STATE OF MAINE
DEPARTMENT OF TRANSPORTATION
16 STATE HOUSE STATION
AUGUSTA, MAINE 04333-0016

March 21, 2014
Subject: **Augusta Phase 2**
State Project No: 020118.20
Amendment No. 1

Make the following change to the Bid Documents:

SKA-01

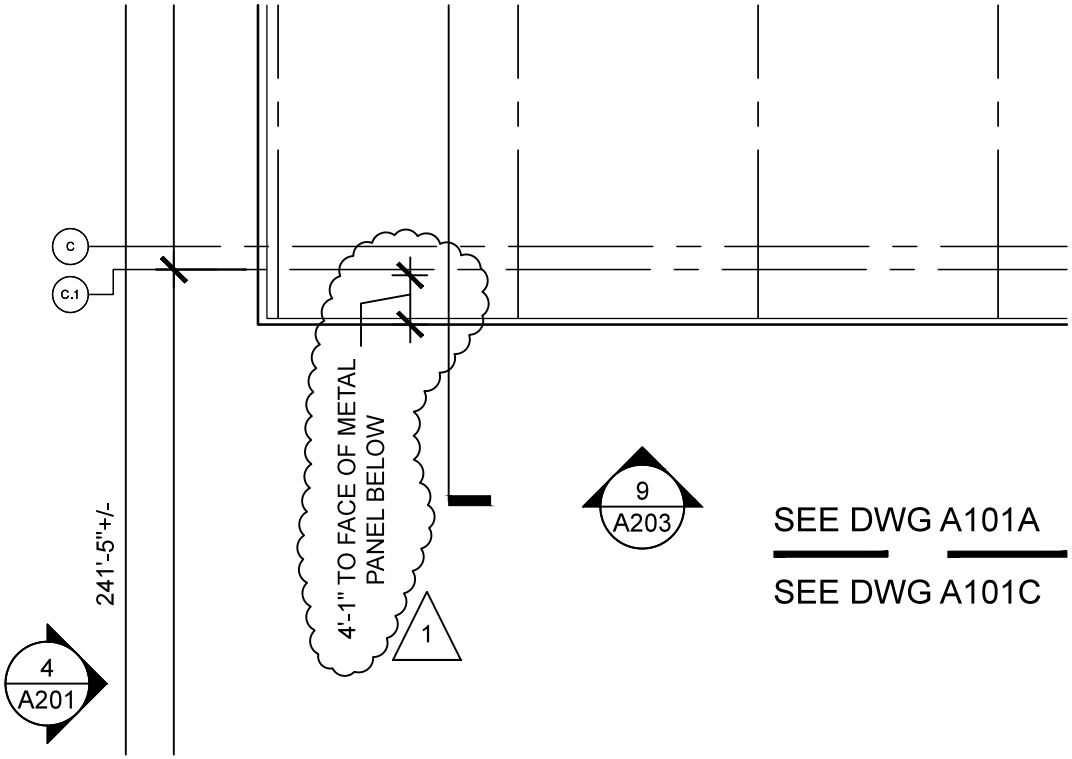
On plan sheet A103 Titled Architectural – Roof Plan Modify dimension per SKA-01 attached.

DIMENSIONAL CLARIFICATION - SEE 1-A103

SKA-02

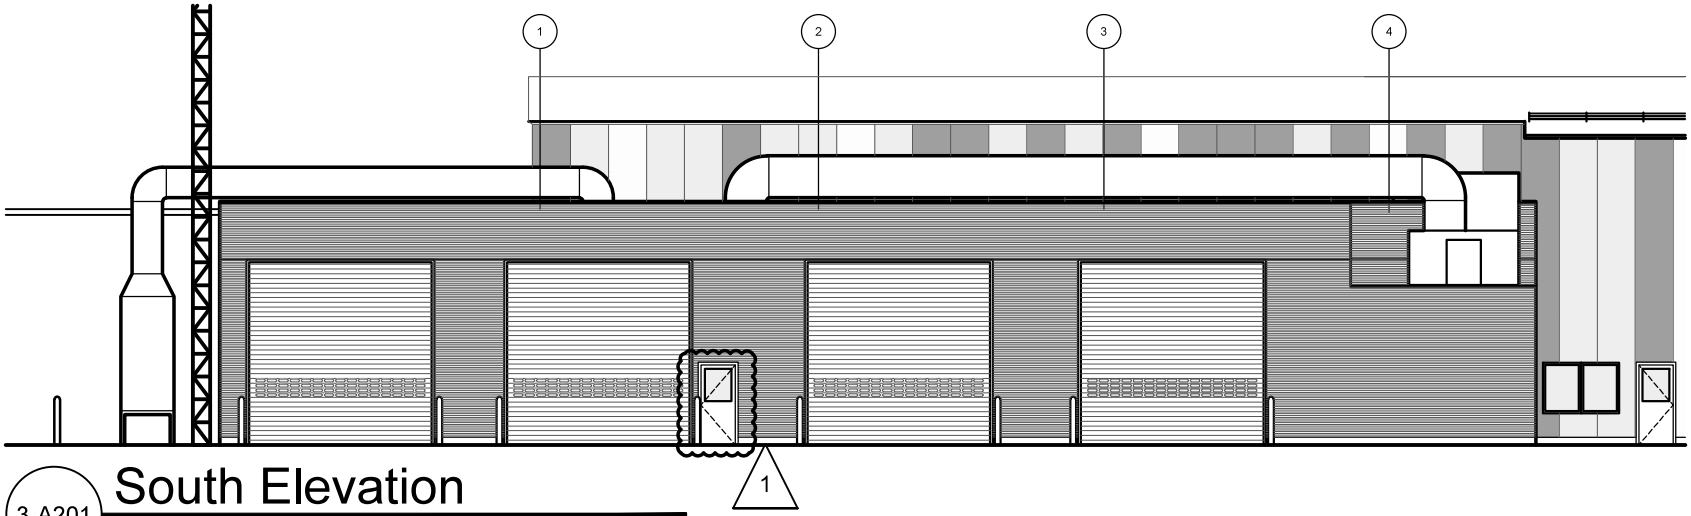
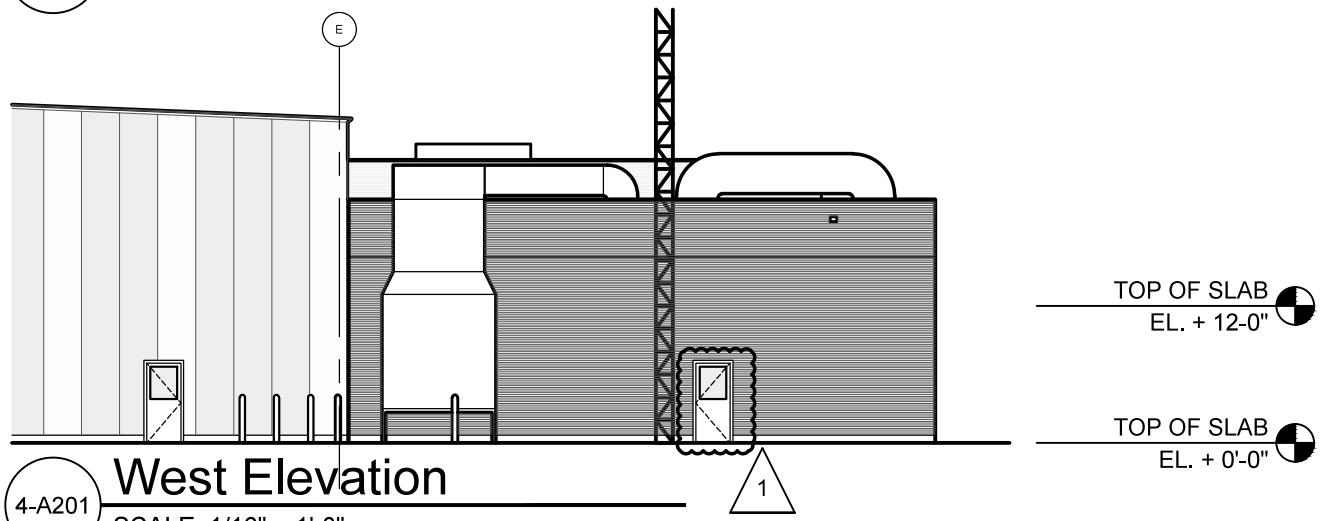
On plan sheet A201 Titled Architectural – Exterior Elevations coordinate elevations 2, 3, & 4 to indicate doors identified on drawings A101C and A601 per SKA-02 attached.

DOOR COORDINATION & NOTE DELETION - SEE A201

SKA-03

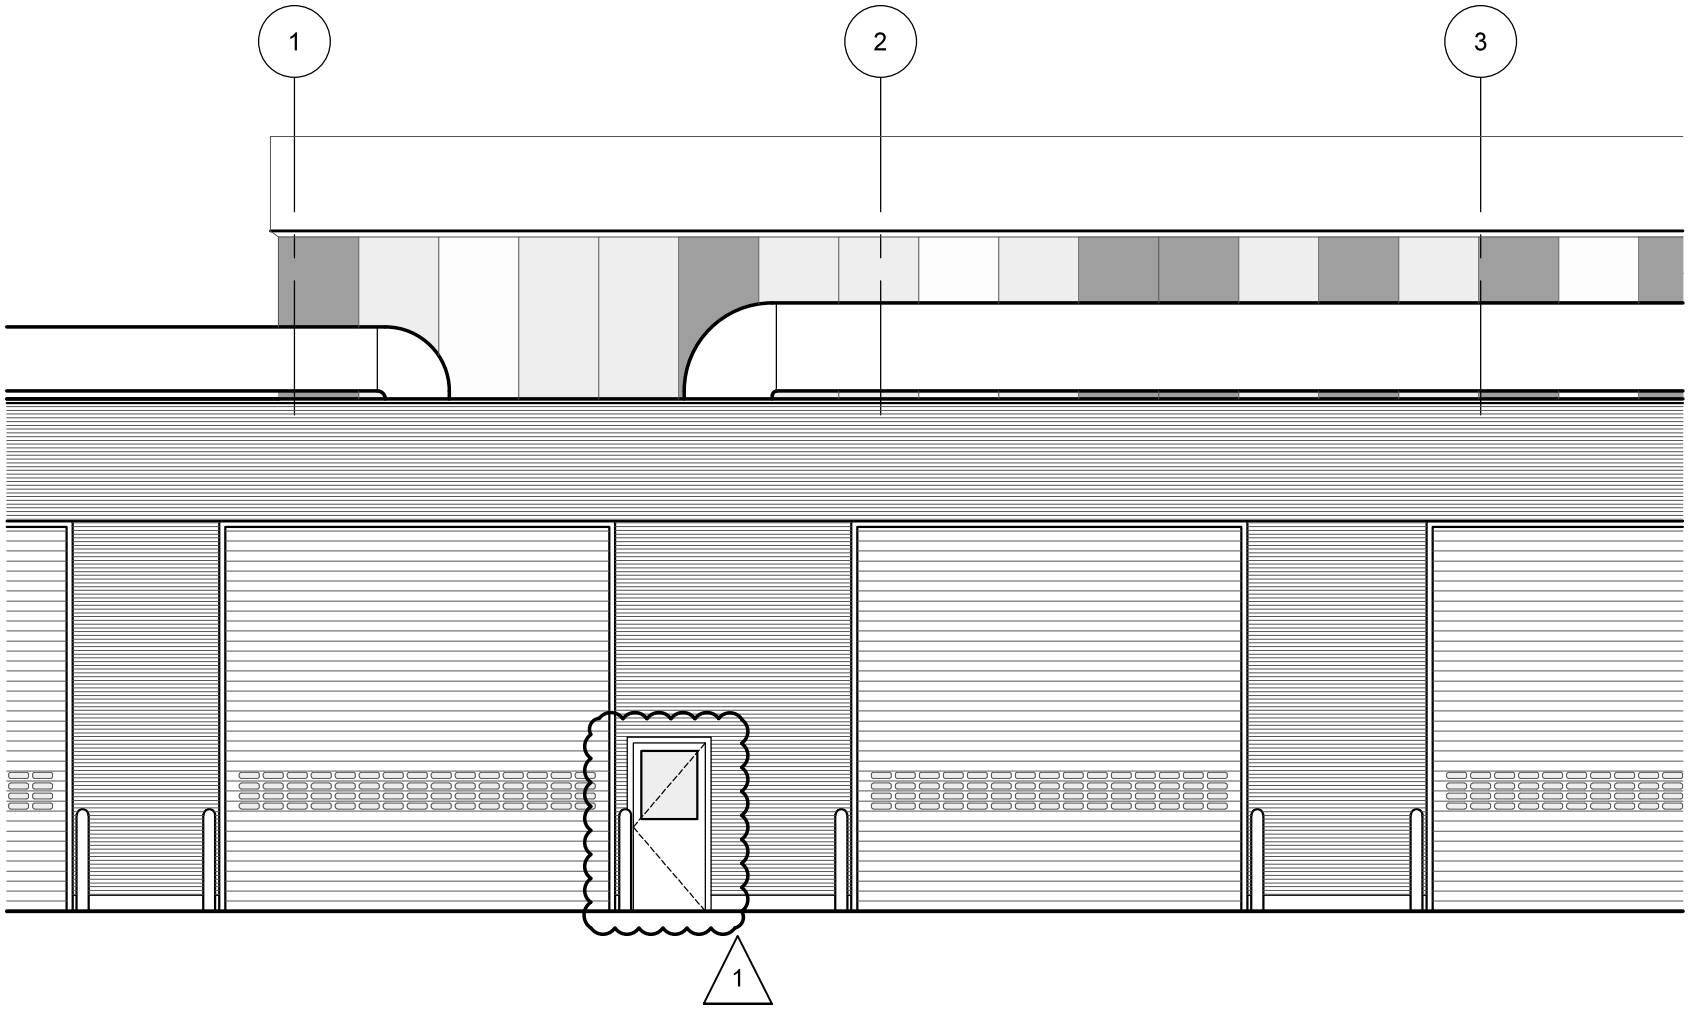
On plan sheet A202 Titled Architectural – Exterior Elevations coordinate elevation to indicate doors identified on drawings A101C and A602 per SKA-03 attached.

DOOR COORDINATION - SEE 6-A202

SKA-04

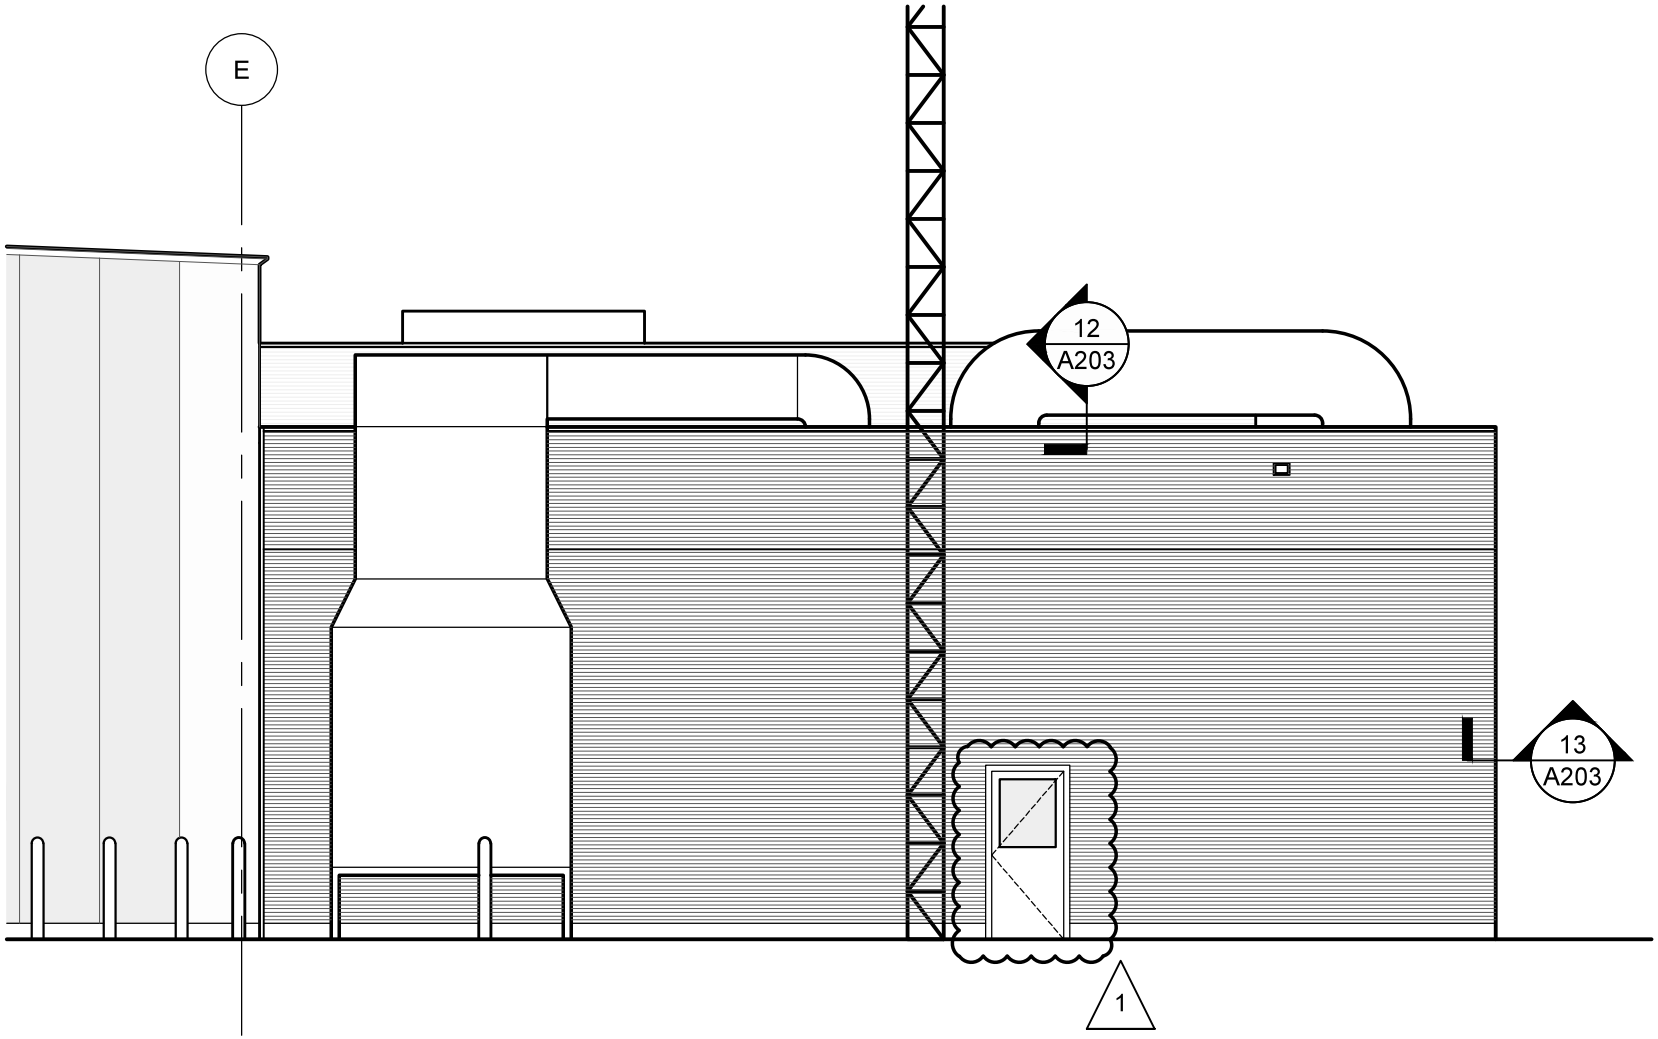
On plan sheet A203 Titled Architectural – Exterior Elevations coordinate elevation to indicate doors identified on drawings A101C and A603 per SKA-04 attached.

DOOR COORDINATION - SEE 7-A203

SKA-05

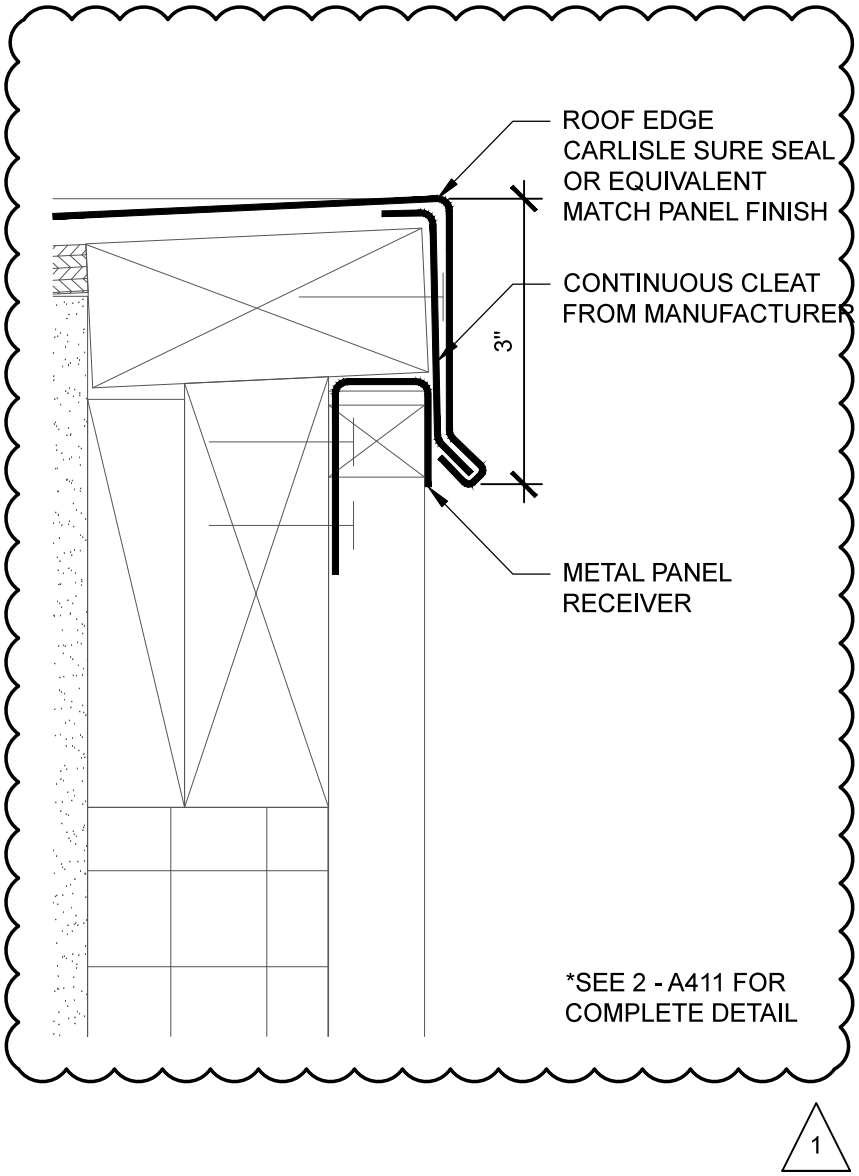
On plan sheet A203 Titled Architectural – Exterior Elevations **DELETE** Detail 12 Roof Edge trim Detail **ADD** in its place Detail 12 Roof Edge trim Detail per SKA-05 attached

ROOF EDGE CLARIFICATION - SEE 12-A203

SKA-06

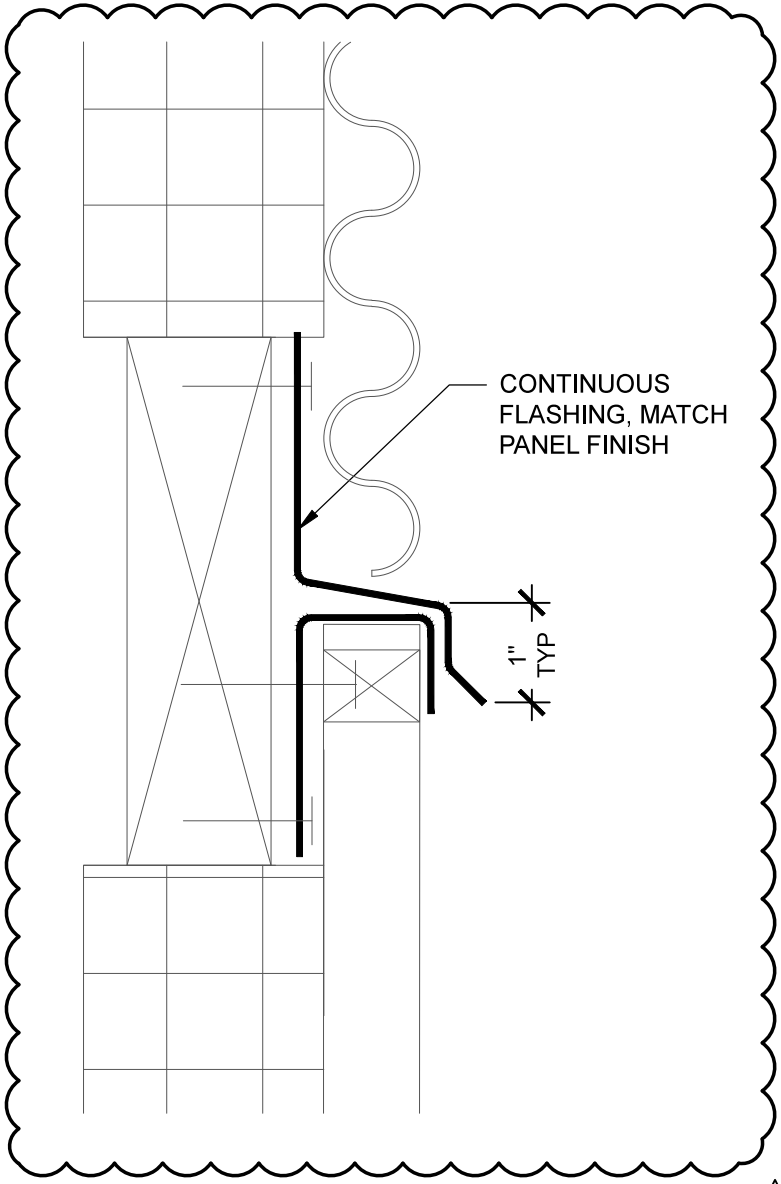
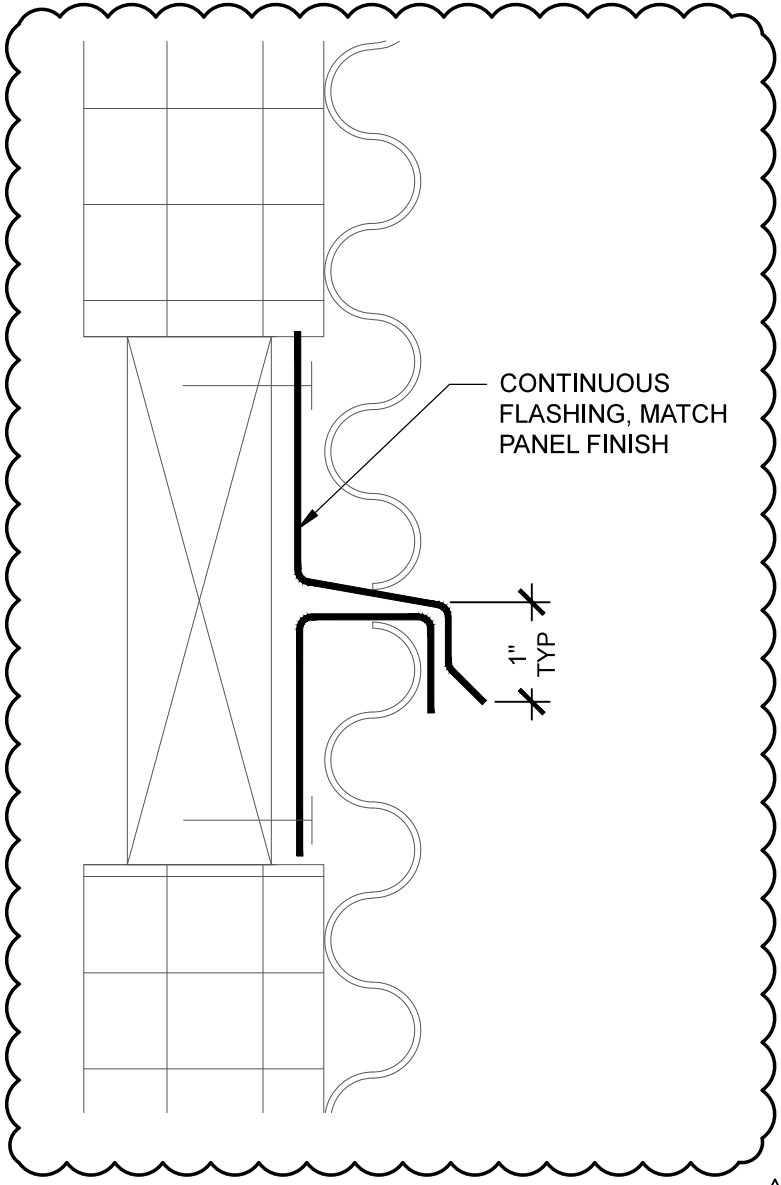
On plan sheet A203 Titled Architectural – Exterior Elevations **DELETE** Detail 15 Panel trim Detail **ADD** in its place Detail 15 Panel Trim Detail and Detail 15A Panel Trim Detail per SKA-06 attached.

FLASHING COORDINATION - SEE A203

SKA-07

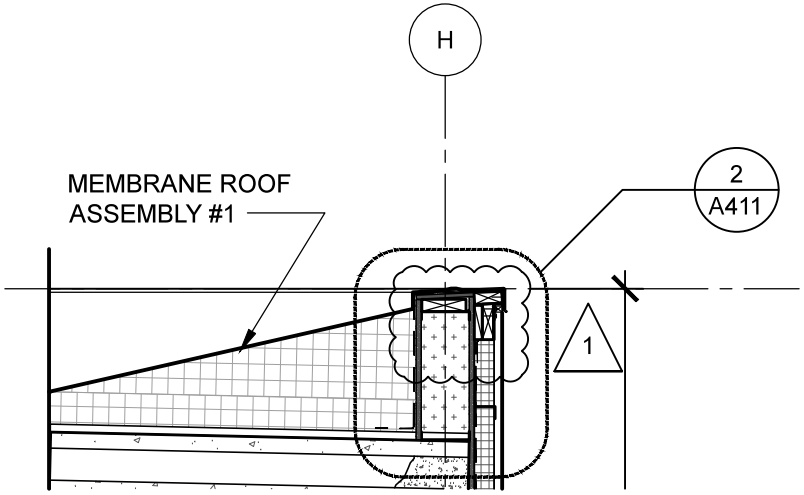
On plan sheet A311 Titled Architectural – Typical Section, at Section 1 Office Addition Wall Section **DELETE** top of section reference to Detail 2/A411 **ADD** in its place top of section reference to Detail 2/A411 per SKA-07 attached

ROOF EDGE MODIFICATION - SEE 1-A311

SKA-08

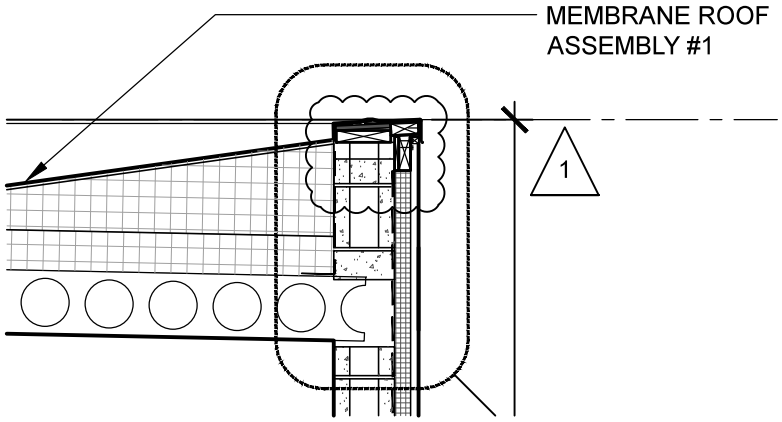
On plan sheet A311 Titled Architectural – Typical Section, at Section 3 Coating BLDG Wall Section **DELETE** top of section reference to Detail 14/A411 **ADD** in its place top of section reference to **Detail** 14/A411 per SKA-08 attached

ROOF EDGE MODIFICATION - SEE 3-A311

SKA-09

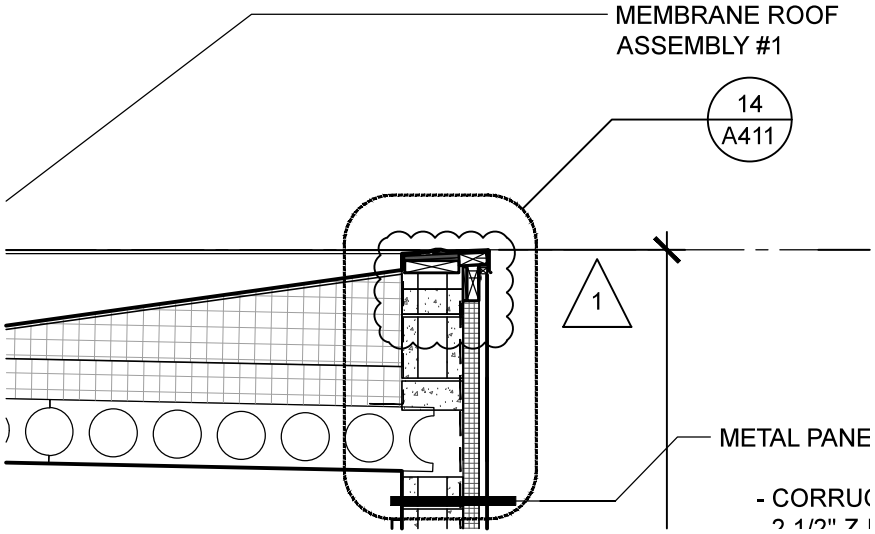
On plan sheet A311 Titled Architectural – Typical Section, at Section 4 Coating BLDG Wall Section at RLNG Door, TYP **DELETE** top of section reference to Detail 14/A411 **ADD** in its place top of section reference to Detail 14/A411 per SKA-09 attached.

ROOF EDGE MODIFICATION - SEE 4-A311

SKA-10

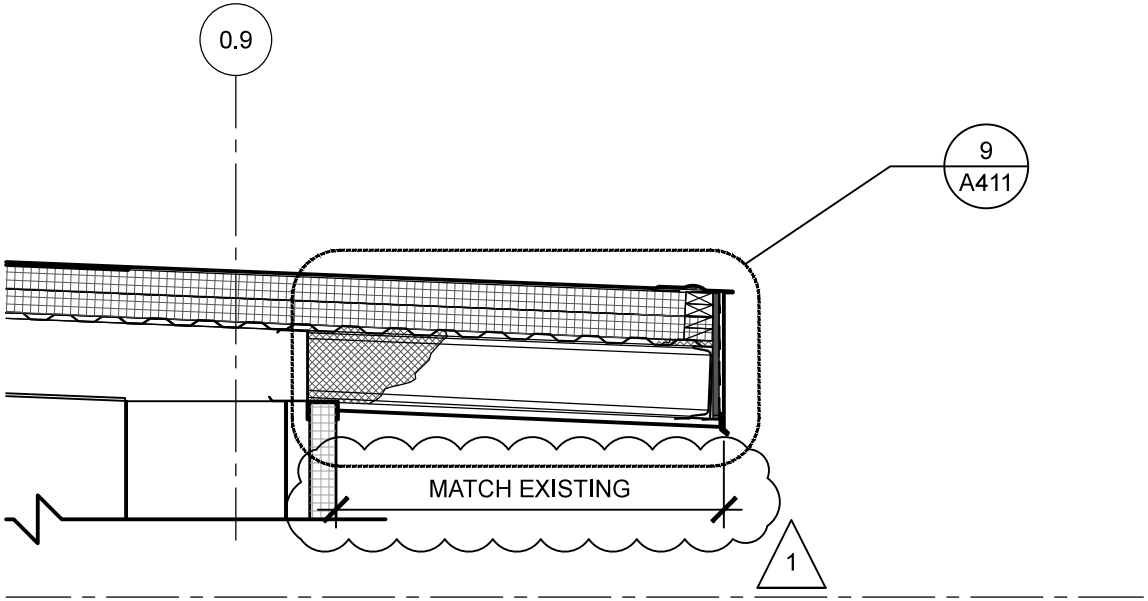
On plan sheet A311 Titled Architectural – Typical Section, at Section 5 Main Building Overhang Section **DELETE** top of section **ADD** in its place top of section per SKA-010 attached.

DIMENSIONAL CLARIFICATION - SEE 5-A311
